T ECHNICAL INFORMATION

57432

- Subject** ▶ Changes on Gear Housing Complete and Screw
- For Models** ▶ 9060L, 9067, 9067L, 9067S, 9069, 9069S
- Country** ▶ All countries
- Description** ▶ As illustrated below, Gear Housing Complete and Screw have been changed for quick repair.

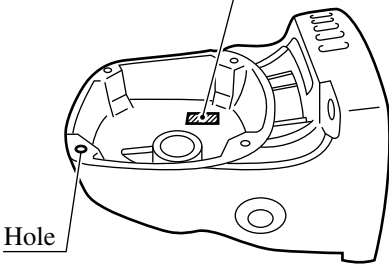
▶ Current	▶ New
Gear Housing Complete	<p>Inscription of "3170064"</p>  <p>Hole</p> <p>(Part No.150968-1)</p>	<p>Inscription of "3172414"</p>  <p>Treatment for Screw M5</p> <p>(Part No.151631-9)</p>
Screw (4pcs.)	 <p>Tapping Screw (Part No.266027-2)</p>	 <p>Pan Head Screw w/spring washer (Part No.911226-8)</p>

Item No.	Current part		Q'ty	I/C	New part		Q'ty	Note
9060L: 038 9067/9067L/ 9067S/9069/ 9069S: 042	Gear housing complete 150968-1		1	No	Gear housing complete 151631-9		1	Interchangeable as a set
9060L: 030 9067/9067L/ 9067S/9069/ 9069S: 034	Tapping screw bind CT 5x16 266027-2		4	No	Pan head screw M5x18 911226-8		4
